Re: Florida Power & Light Company
Proposed Turkey Point Units 6 and 7
Docket Nos. 52-040 and 52-041
Response to NRC Request for Additional Information Letter No. 037
(eRAI 5896) SRP Section - 02.05.02 Vibratory Ground Motion

FPL Response to NRC RAI No. 02.05.02-2 (eRAI 5896)

NRC RAI Number: 02.05.02-2 (eRAI 5896)

Re: Florida Power & Light Company
Proposed Turkey Point Units 6 and 7
Docket Nos. 52-040 and 52-041
Response and Response Schedule to NRC Request for Additional Information
Letter No. 037 (eRAI 5896) SRP Section - 02.05.02 Vibratory Ground Motion

Figure 14c. Caribbean 0.5Hz weighted mean attenuation curve for a magnitude 8 earthquake.

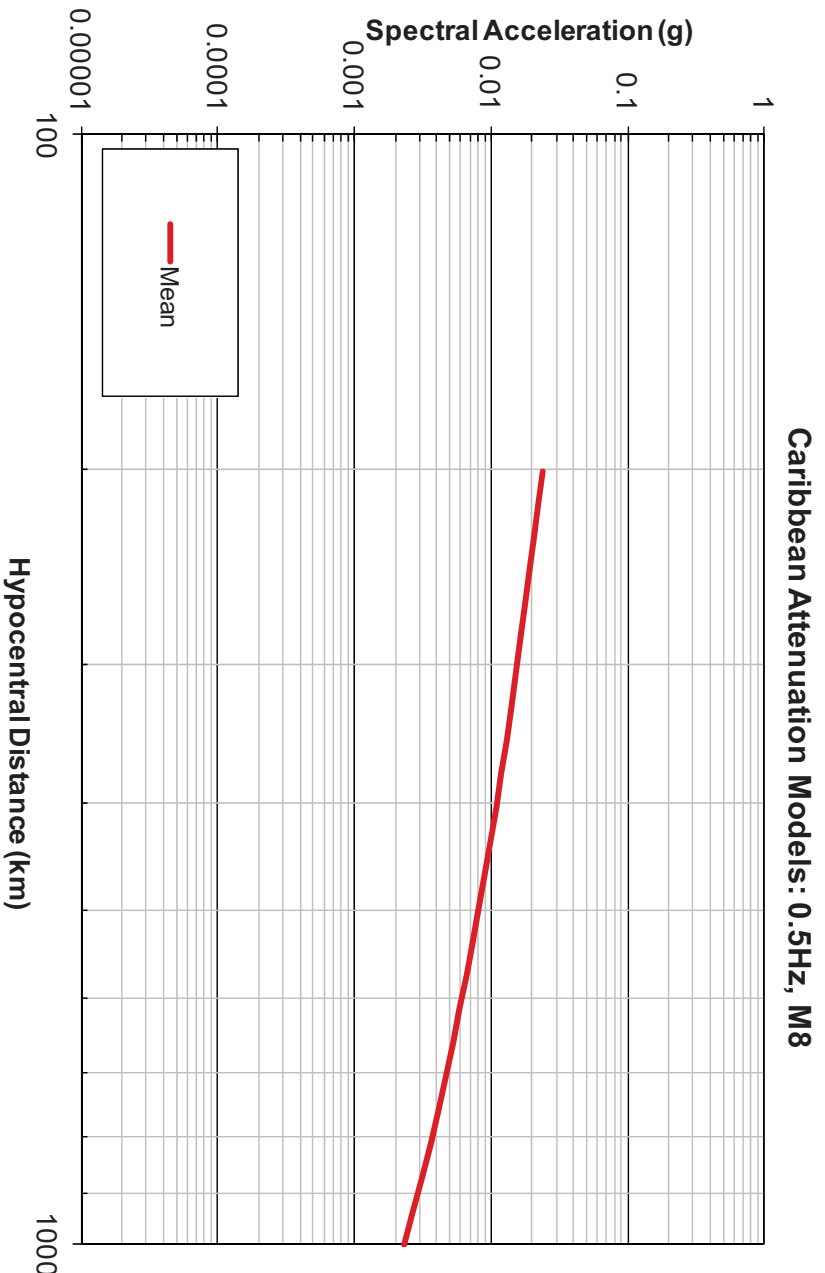
- d. In order for the staff to be able to compare the new Caribbean GMPEs with the 2004/2006 EPRI mid-continent GMPEs, please provide plots showing both ground motion models for earthquake magnitudes of 6.0, 7.0, and 8.0 in the distance range of 200 km to 1000 km at all seven frequencies defined in the EPRI 2004 and 2006 GMPEs.

Ground motion attenuation curve plots are provided for the EPRI (FSAR References 242 and 203) and Caribbean ground motion prediction equations (GMPEs). Note that EPRI (FSAR Reference 203) is only a recommendation for the associated aleatory uncertainty and therefore does not impact the comparison plots of the weighted mean ground motion

attenuation curve. The plotted mean attenuation curve is the weighted mean of the individual median attenuation curves as defined in EPRI (FSAR Reference 242). These attenuation plots are provided for three specific moment magnitude (M_w) values: 6, 7, and 8 for distances between 200 km and 1,000 km. Note that the EPRI (FSAR Reference 242) ground motion attenuation model is defined as a function of epicentral distance, whereas the Caribbean ground motion attenuation model is defined as a function of hypocentral distance. However, because the closest distance is 200 km, the difference between the epicentral and hypocentral distances would be less than 1% for a typical crustal depth of 10 km and even smaller for larger distances out to 1,000 km.

The weighted mean ground motion attenuation curves for the EPRI (FSAR Reference 242) model are given in Figures 1 through 7 for the three magnitudes and seven spectral frequencies requested in the RAI. The weighted mean Caribbean ground motion attenuation curve plots for the same suite of magnitudes, distances, and spectral frequencies are shown in Figures 8 through 14.

Figure 1. Compression Wave Velocity Profiles for Sonic Logs 0001, 0002, 0005, 0007, 0008, 0010, LAB-TW and PBF-12

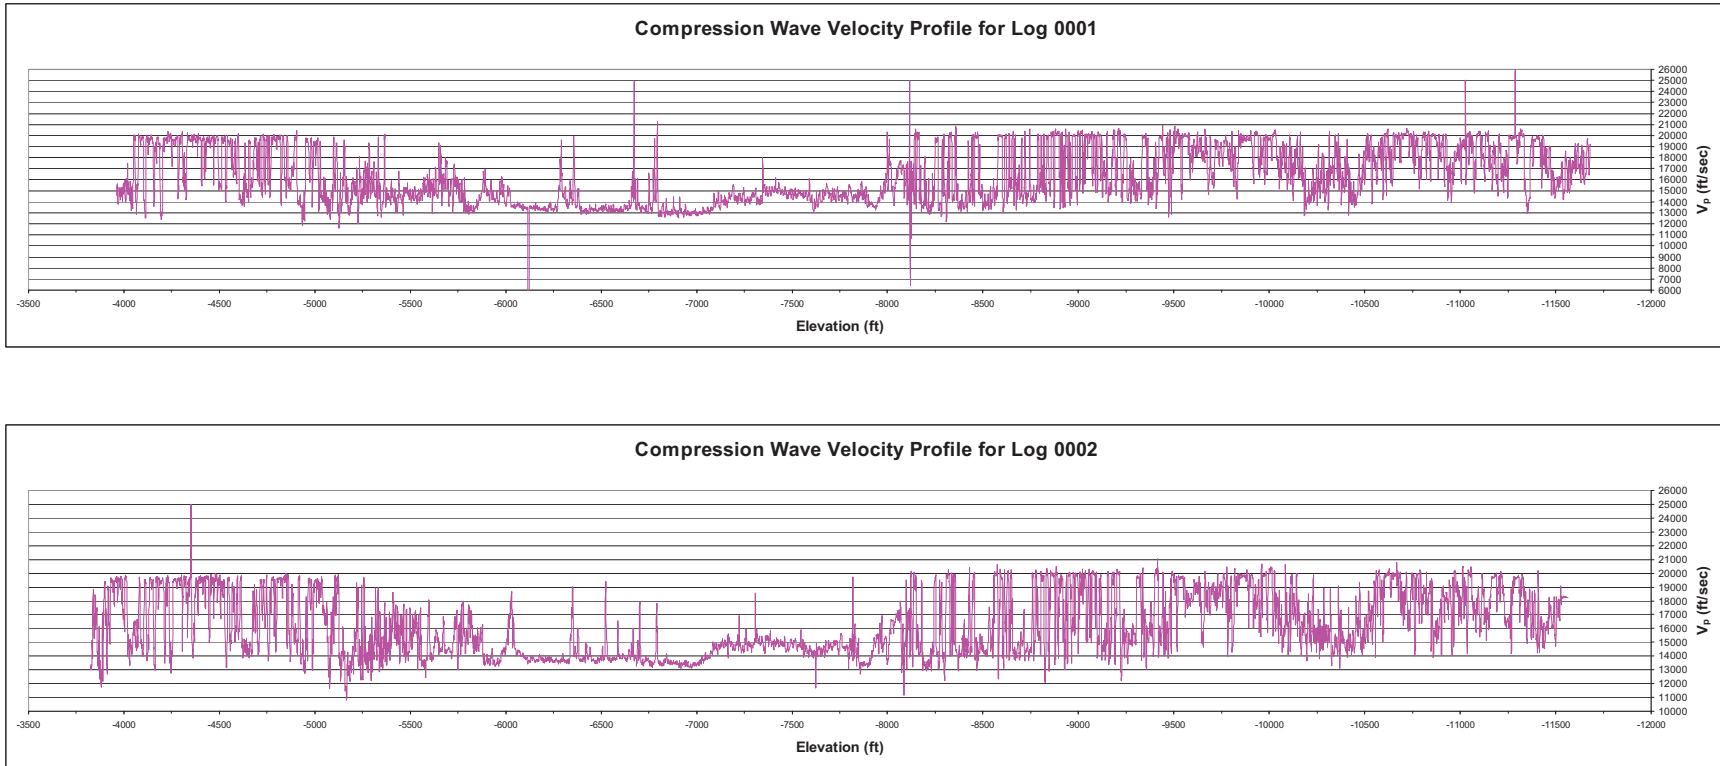
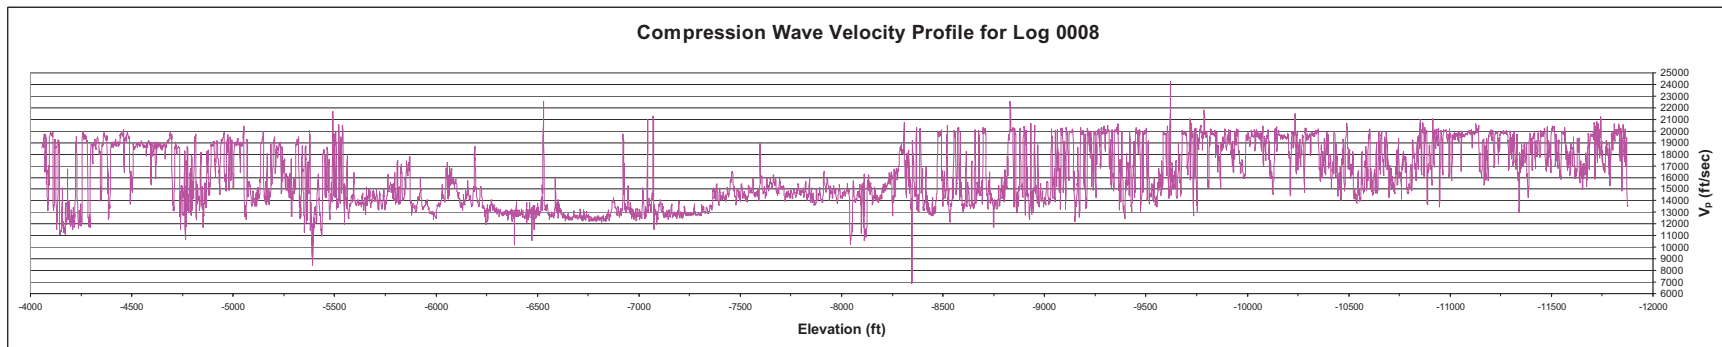
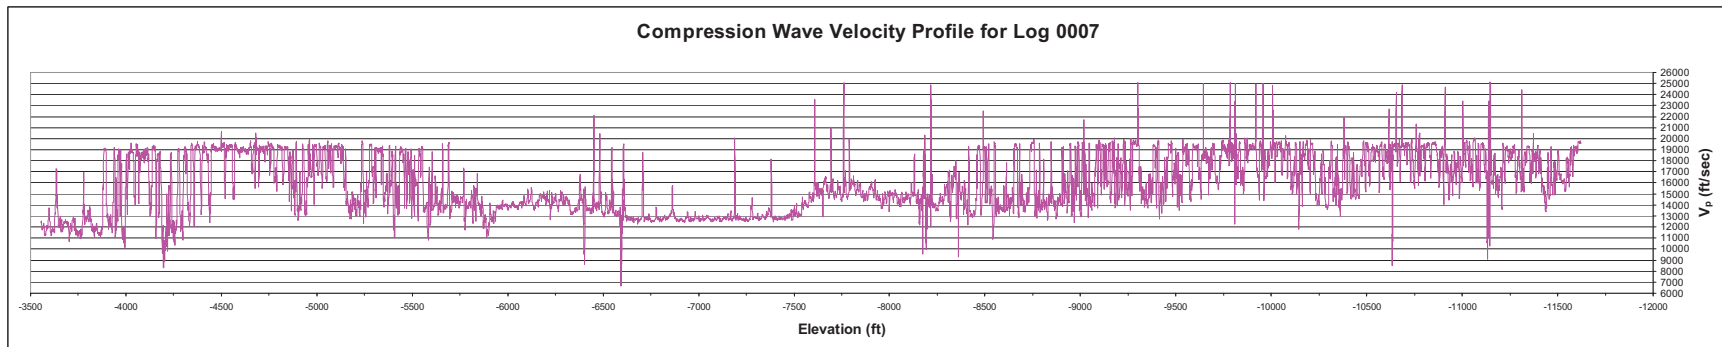
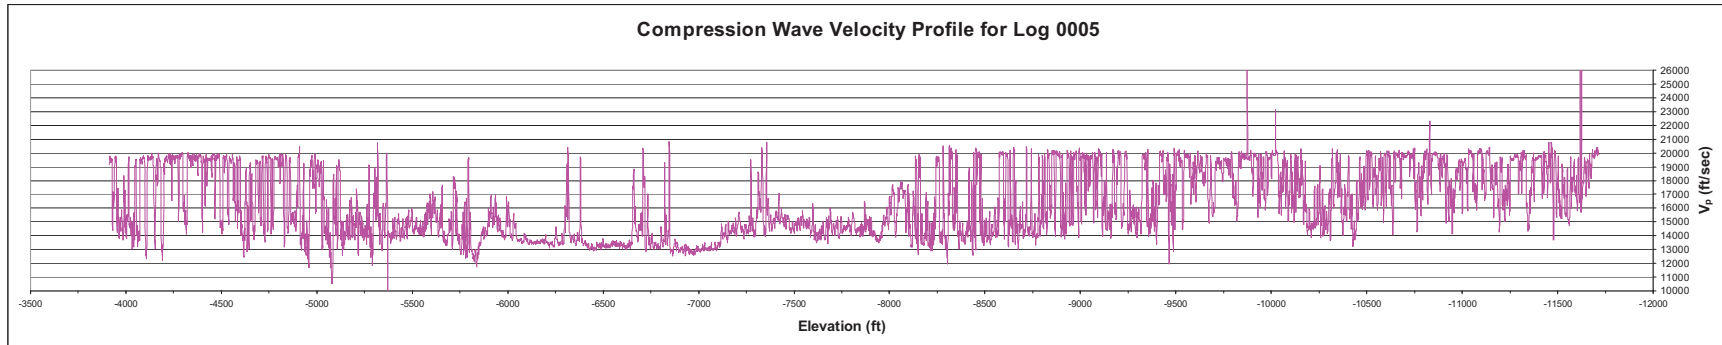
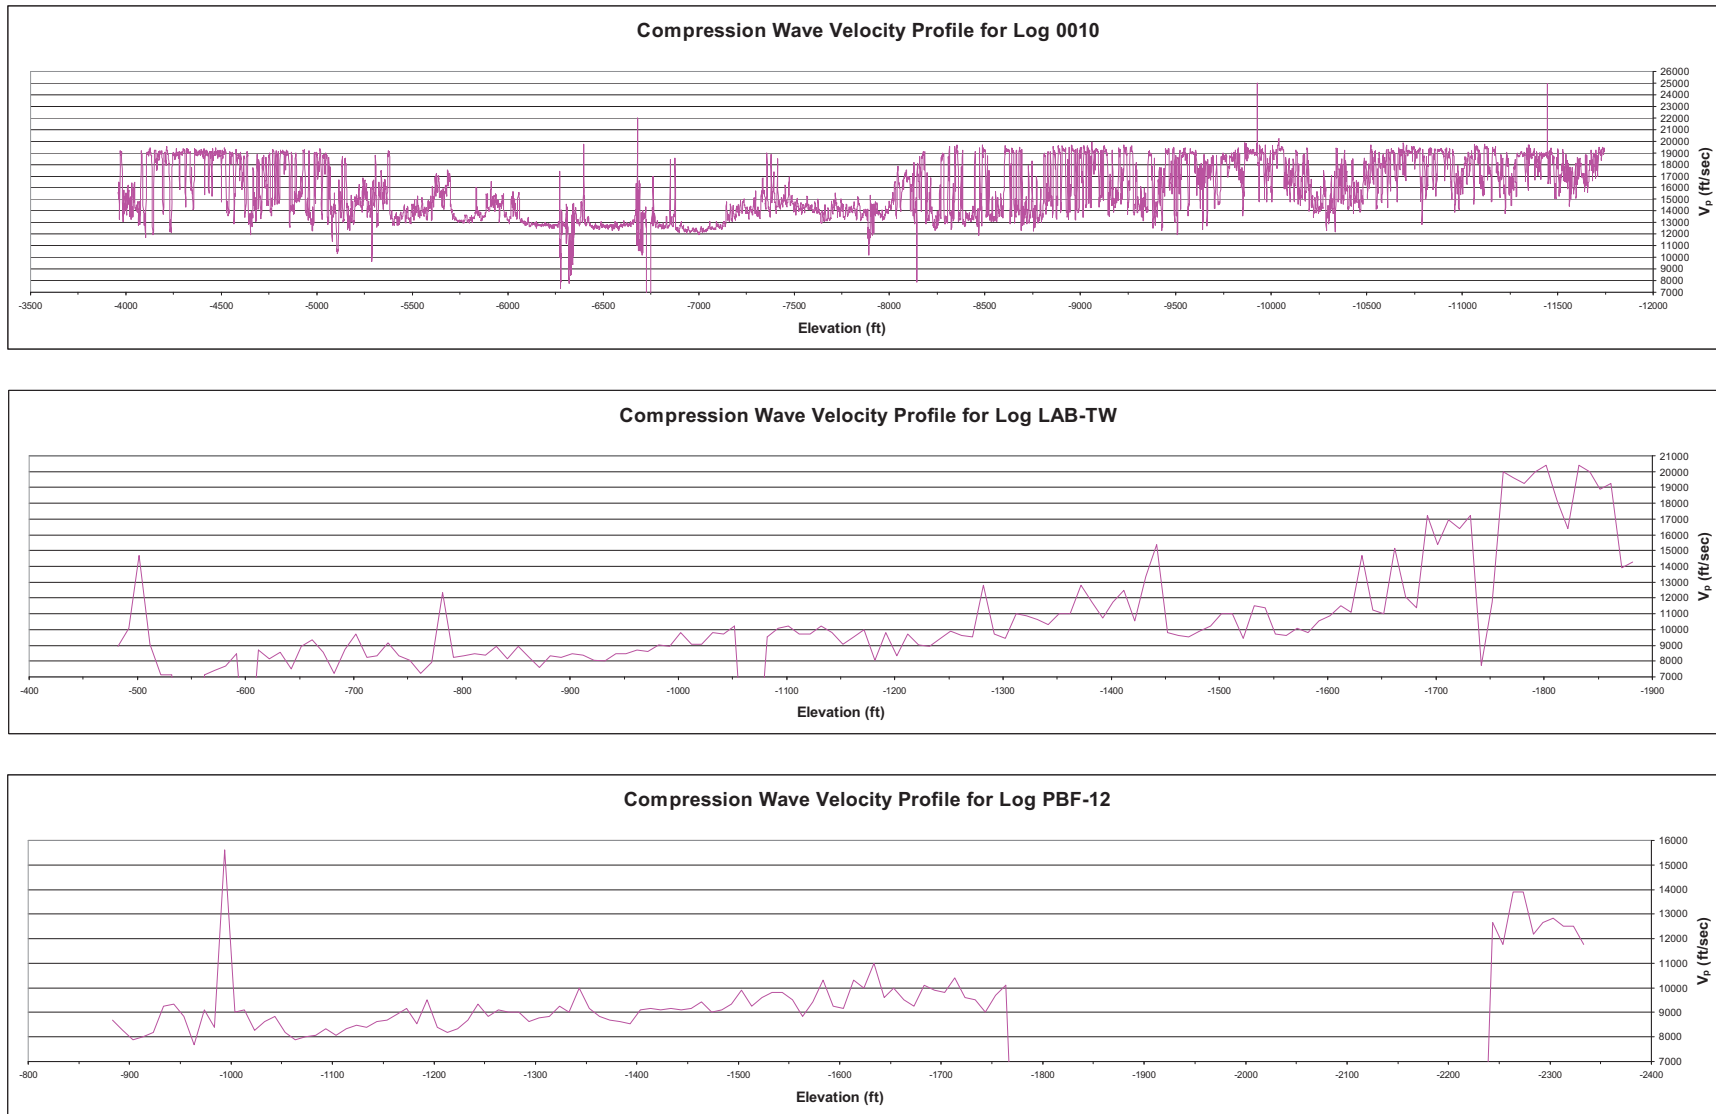
- a. additional information on the applicability of seismic velocity information obtained at such great distances to the Turkey Point site. How was the variation in geology considered in these projections?
- b. individual velocity profiles for each of the eight wells used in estimating the average profile shown in FSAR Figure 2.5.4-211
- c. further details on how larger uncertainties in deeper layers' thicknesses/depths are taken into account in the randomization of the site profile

- b) The velocity profiles for each of the 8 wells are shown in Figure 1.
- c) The uncertainties in the dynamic properties of the deeper layers were taken into account by the following two steps.
